ADDENDUM NO. 2

for
**PUBLIC ADDRESS AND CLOCK SYSTEM REPLACEMENT AT VARIOUS
MANALAPAN-ENGLISHTOWN REGIONAL SCHOOLS**
School, 118 Millhurst Road, Manalapan, NJ 07726

Issued: May 1, 2026

FVHD PROJECT NO. 5618

Drawing Number
E601PB

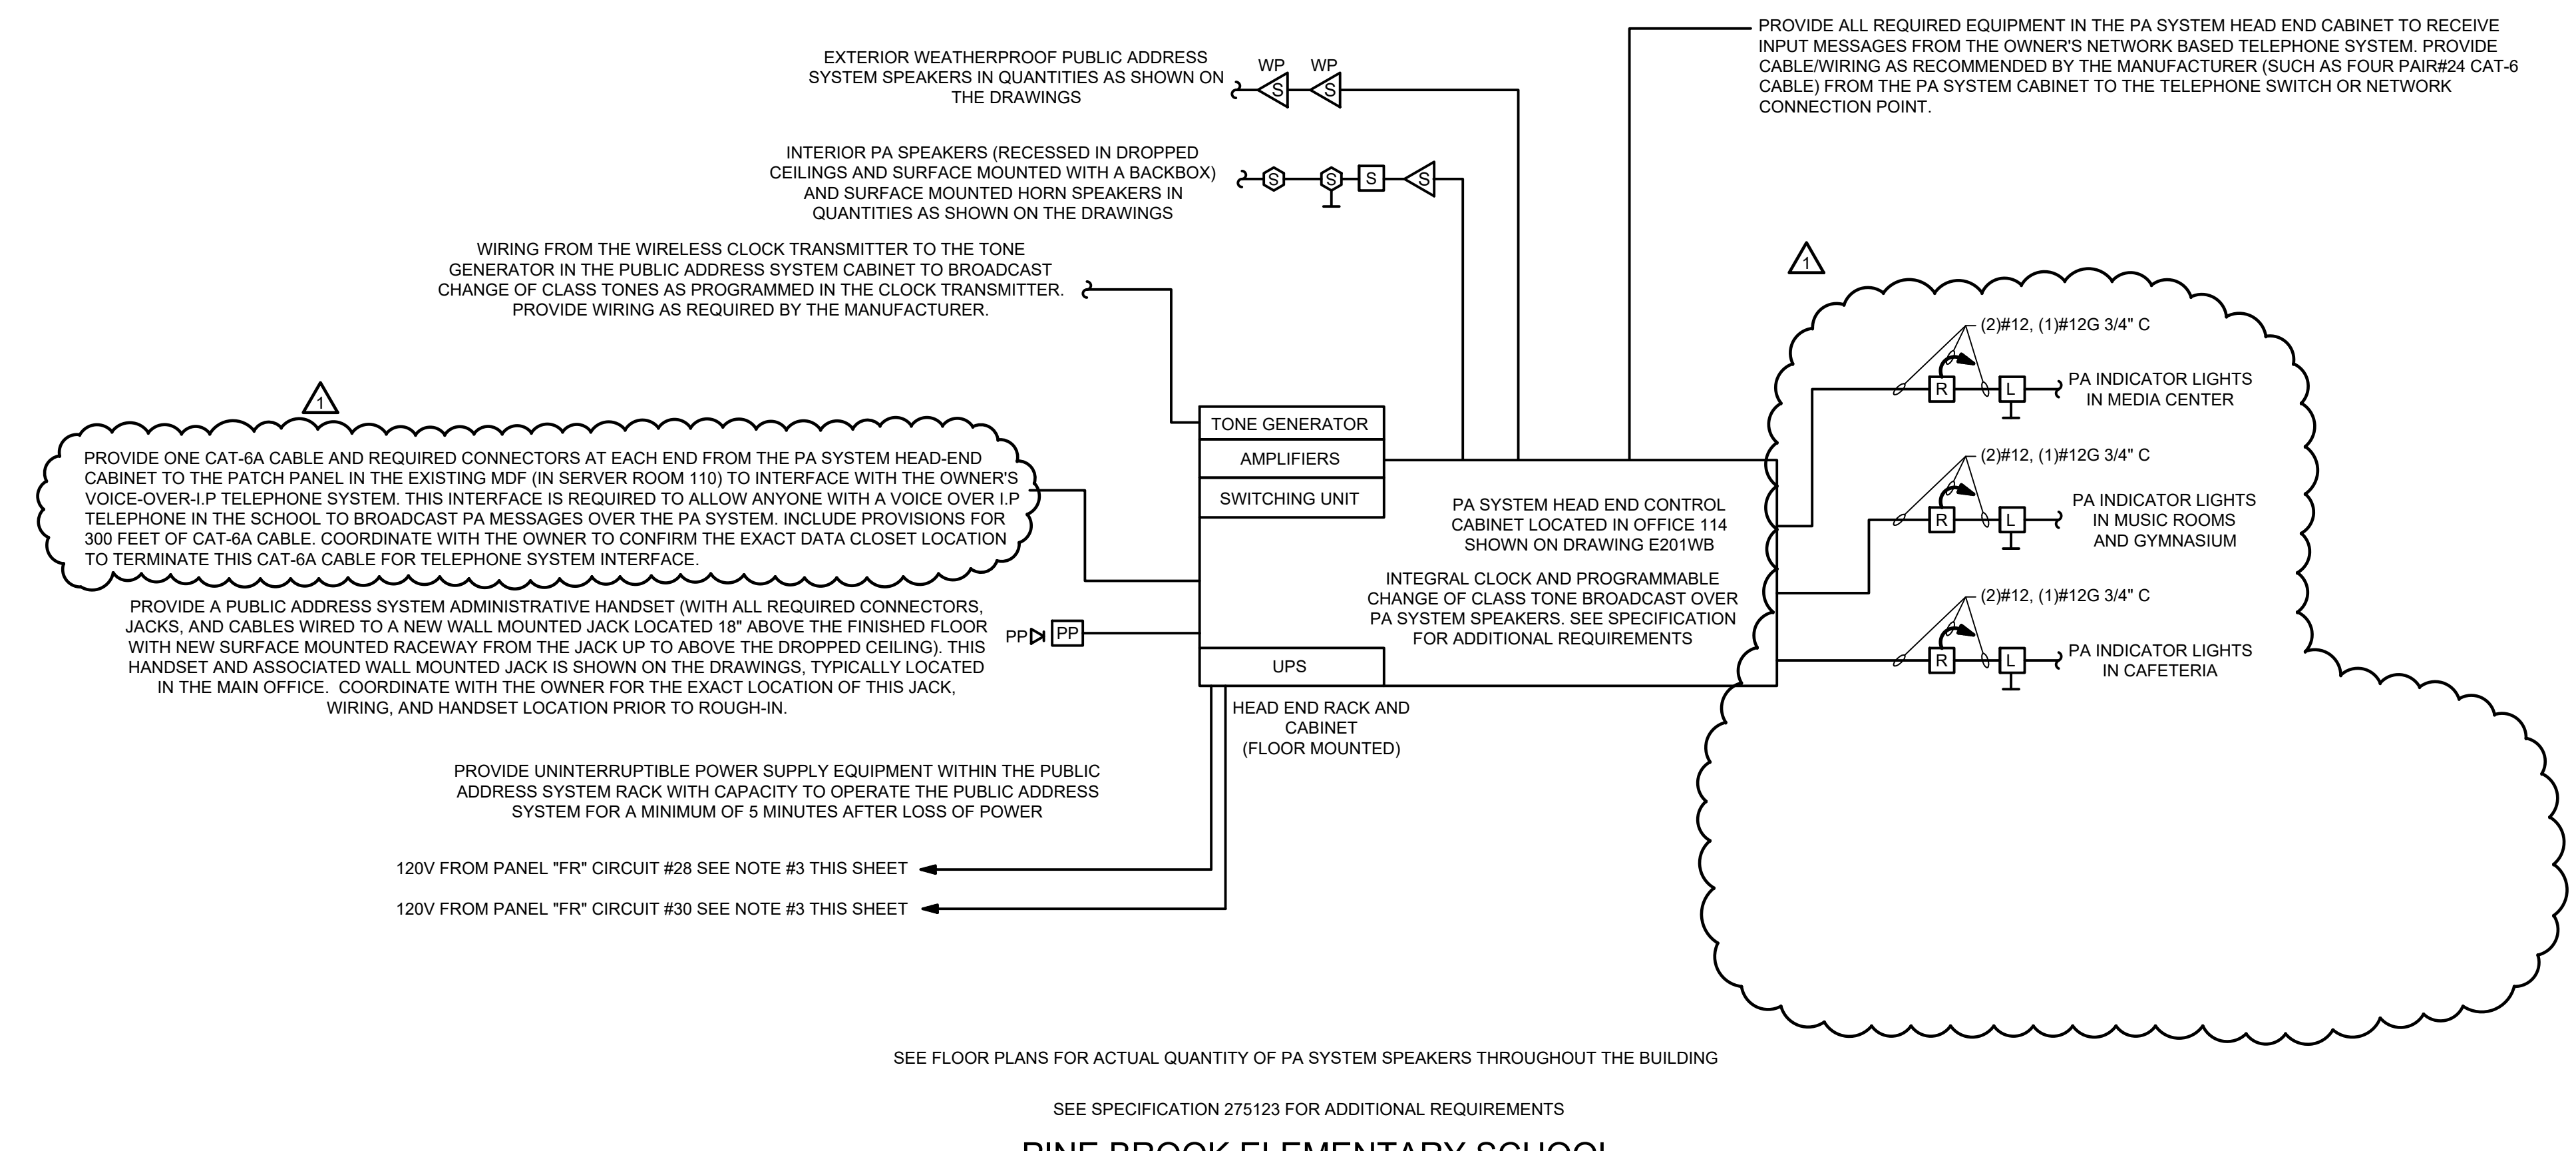
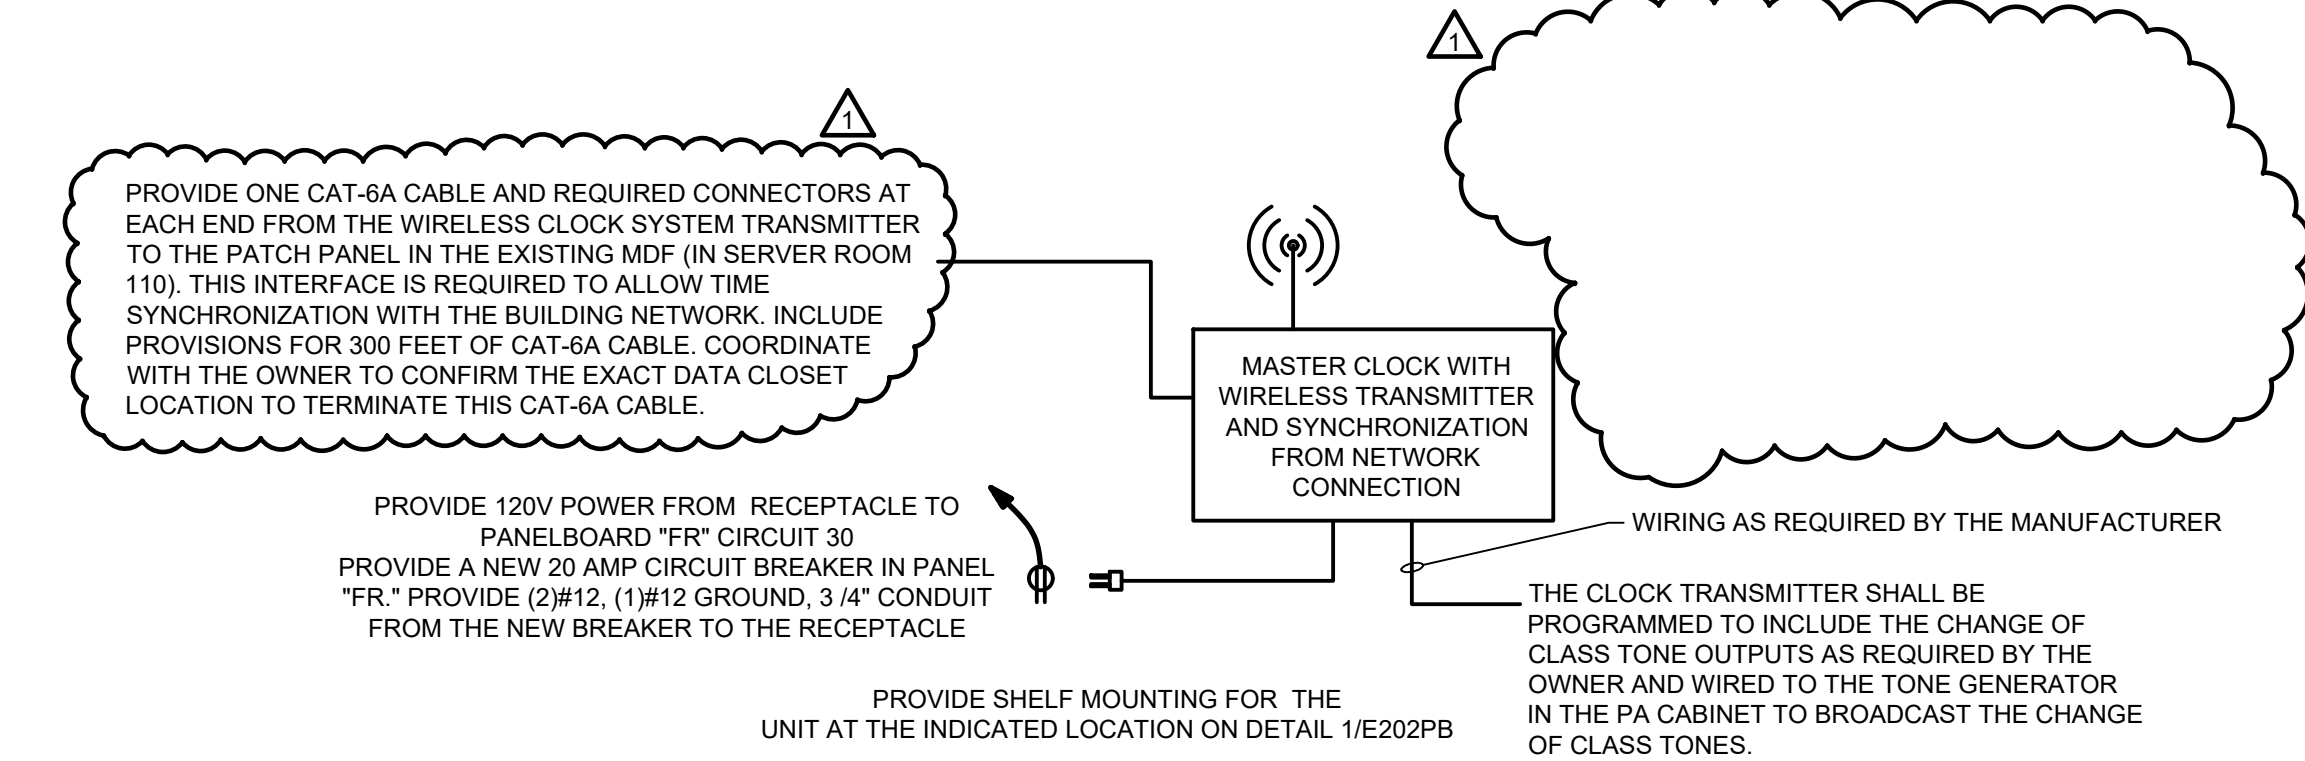
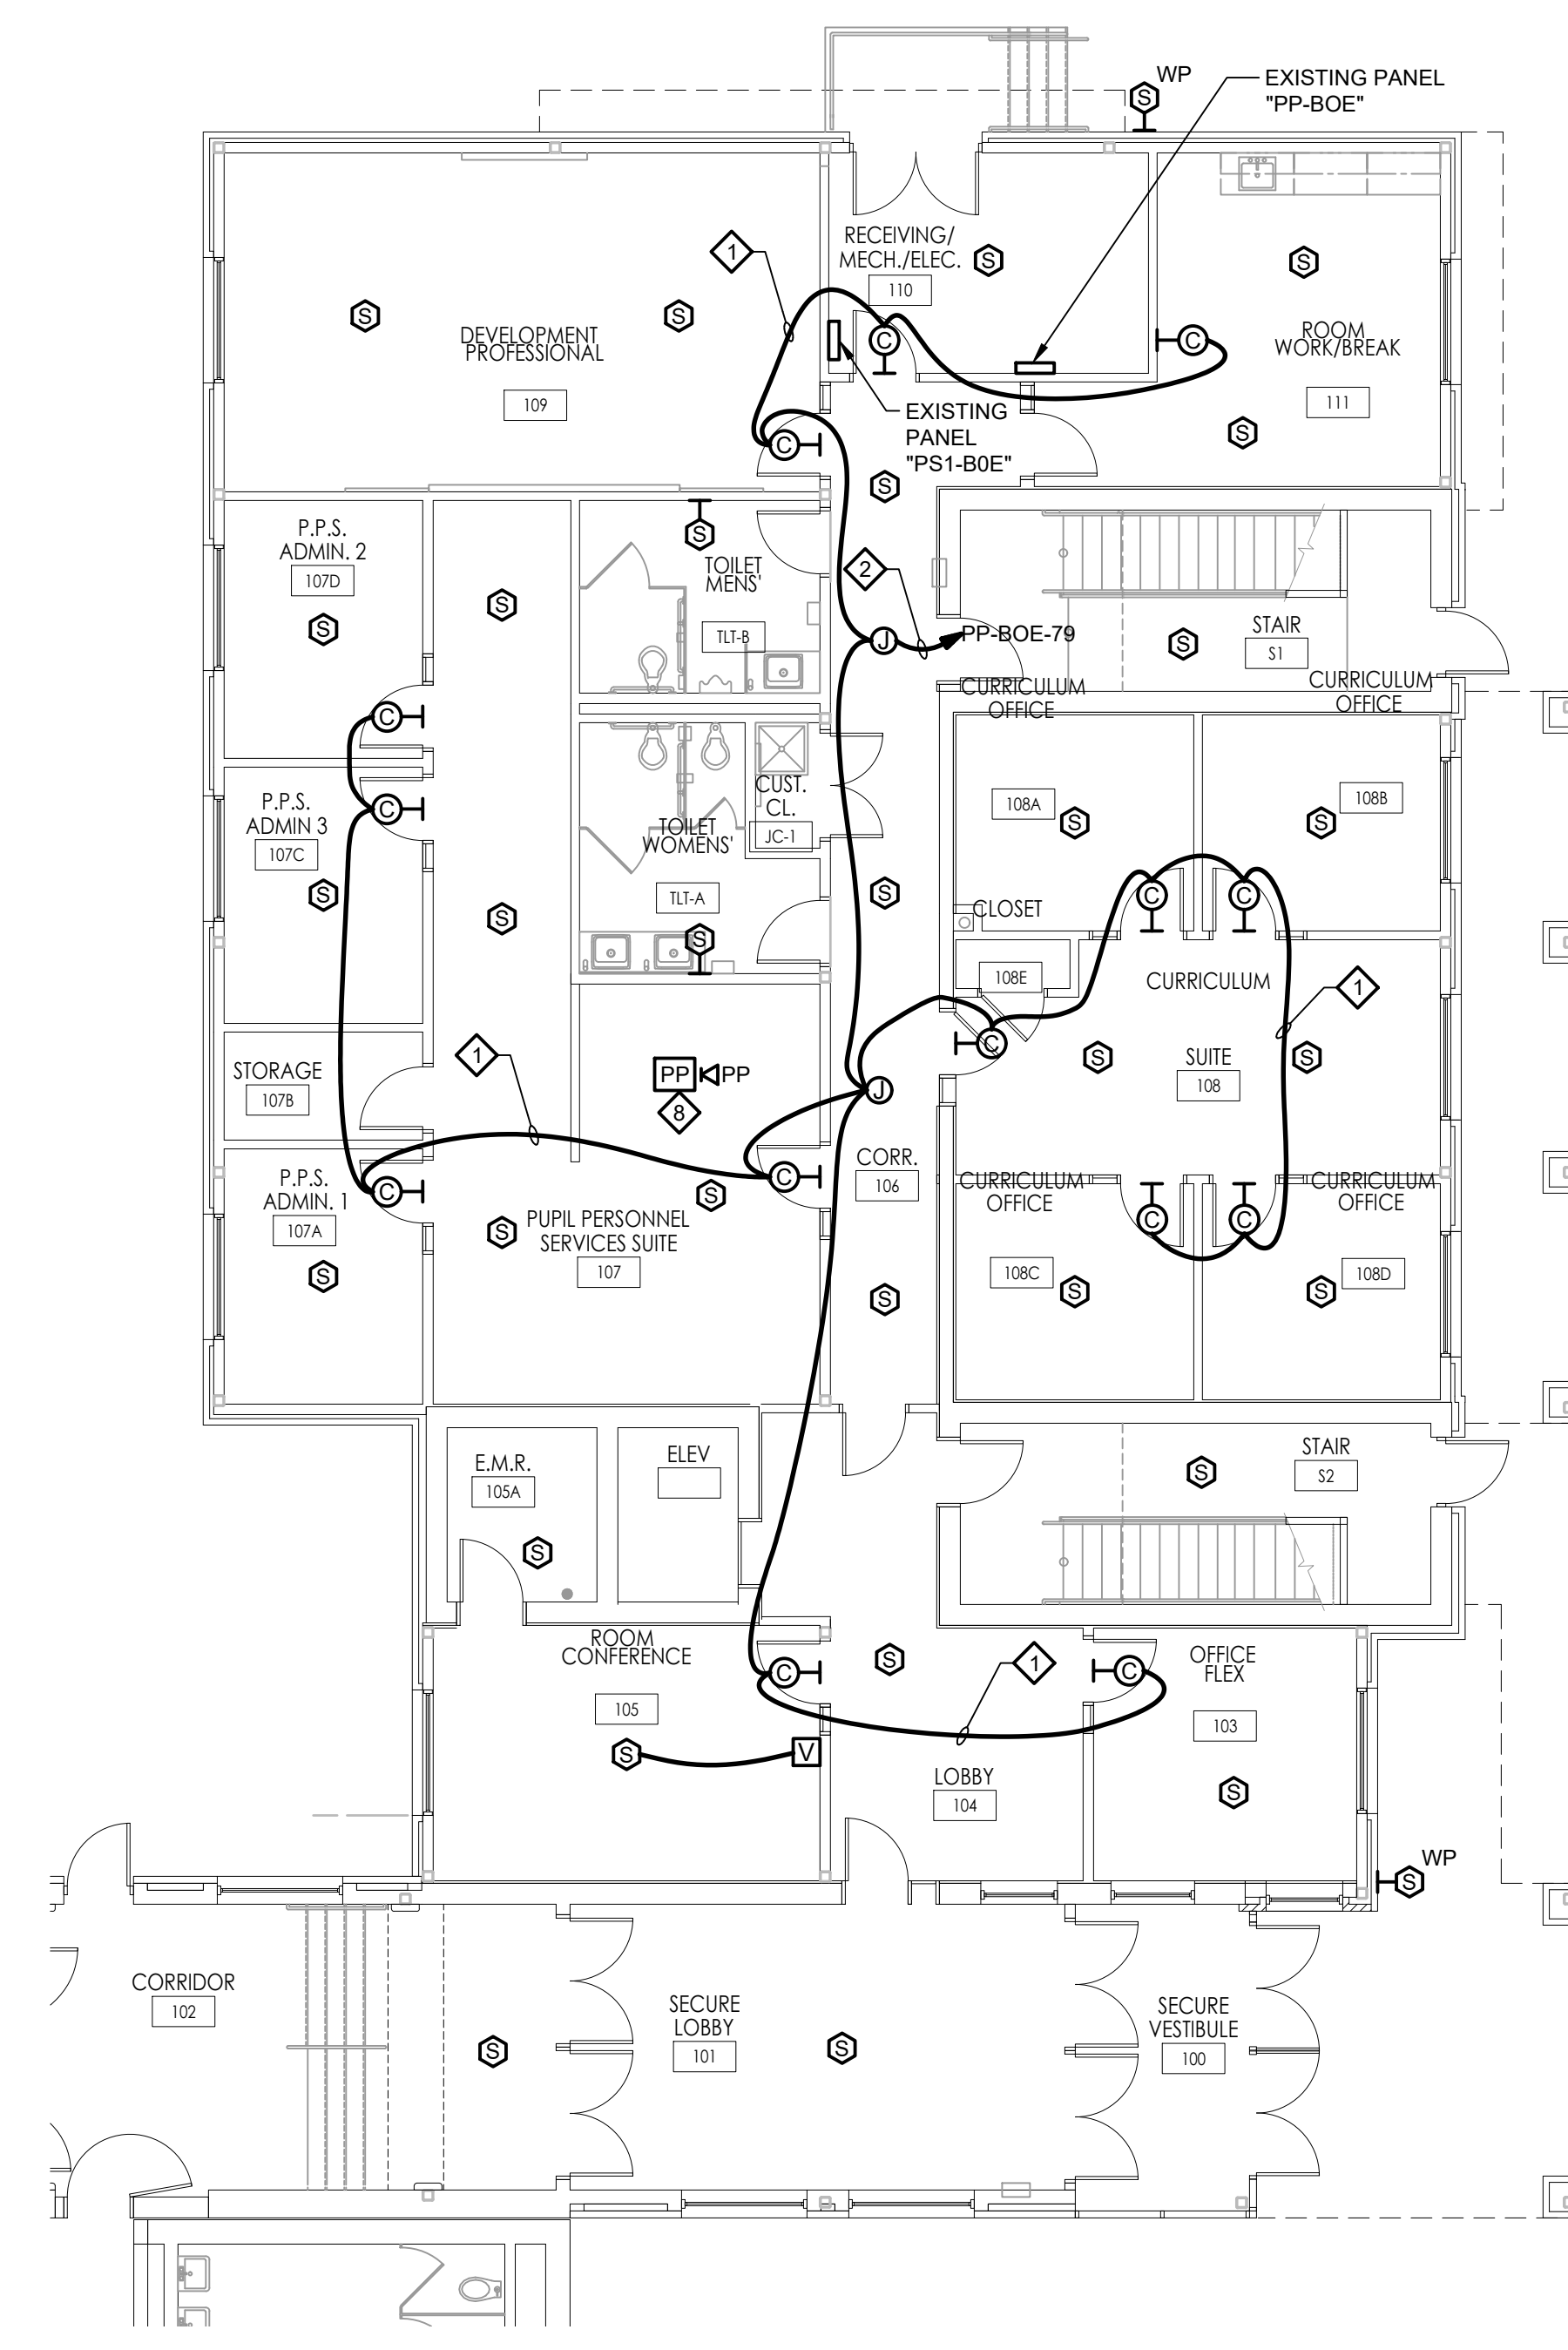
- 2.1.8 Removed Milford Brook Drawings E101MB, E102MB, E201MB, E202MB, E601MB.
- 2.1.9 Pine Brook Drawings E101PB, E102PB, E201PB, E202PB, E601PB: Revised as indicated.
- 2.1.10 Removed Taylor Mills Drawings E101TM, E102TM, E103TM, E201TM, E202TM, E203TM, and E601TM.
- 2.1.11 Removed Wemrock Brook Drawings E101WB, E102WB, E103WB, E104WB, E105WB, E201WB, E202WB, E203WB, E204WB, E205WB, and E601WB.

UNDER THE BASE BID, INCLUDE PROVISIONS IN THE PUBLIC ADDRESS SYSTEM CONTROL CABINET FOR A NETWORK TIME SYNCHRONIZED PUBLIC ADDRESS SYSTEM CONTROLLER/DIGITAL SIGNAL PROCESSOR/PAGING SERVER WITH ALL REQUIRED SYSTEM PROGRAMMING, SOFTWARE, AND EQUIPMENT THAT CAN PROVIDE (WITHOUT A SEPARATE CLOCK SYSTEM) CHANGE OF CLASS BELL/TONE SIGNALS OVER THE PUBLIC ADDRESS SYSTEM SPEAKERS. THE TIME SYNCHRONIZATION EQUIPMENT SHALL INCLUDE A CAT-6A CABLE CONNECTION EXTENDED TO THE OWNERS DATA NETWORK PATCH PANEL TO MAINTAIN ACCURATE SYSTEM TIME FROM THE OWNERS DATA NETWORK SYSTEM. THE CONTROLLER SHALL BE PROVIDED WITH A PROGRAMMABLE SCHEDULING CHANGE OF CLASS/BELL CONTROLLER WITH ALL REQUIRED SOFTWARE TO MAINTAIN A MINIMUM OF THREE DAILY CHANGE OF CLASS CALENDAR BASED SCHEDULES. THE SYSTEM SHALL INCLUDE A TONE GENERATOR WITH MULTIPLE STYLES OF TONES AS SELECTED BY THE OWNER AND ALLOW LIVE PAGING PRIORITY OVERRIDE. THE SYSTEM SHALL INCLUDE PROVISIONS FOR THE SCHOOL STAFF TO MANAGE THE CHANGE OF CLASS USING A DATA NETWORK SYSTEM BASED INTERFACE THAT IS PROVIDED WITH ALL REQUIRED NETWORK SOFTWARE AND LICENSING. A SEPARATE CAT-6A JACK AND CABLE CONNECTED TO THE SCHOOL'S DATA NETWORK SYSTEM SHALL BE PROVIDED FOR THIS SYSTEM CONTROL IF REQUIRED. IF THE ADD ALTERNATE FOR THE CLOCK SYSTEM IS ACCEPTED, THIS TIME SYNCHRONIZATION AND CHANGE OF CLASS PROGRAMMING CAN BE PROVIDED IN THE CLOCK SYSTEM CONTROLLER.
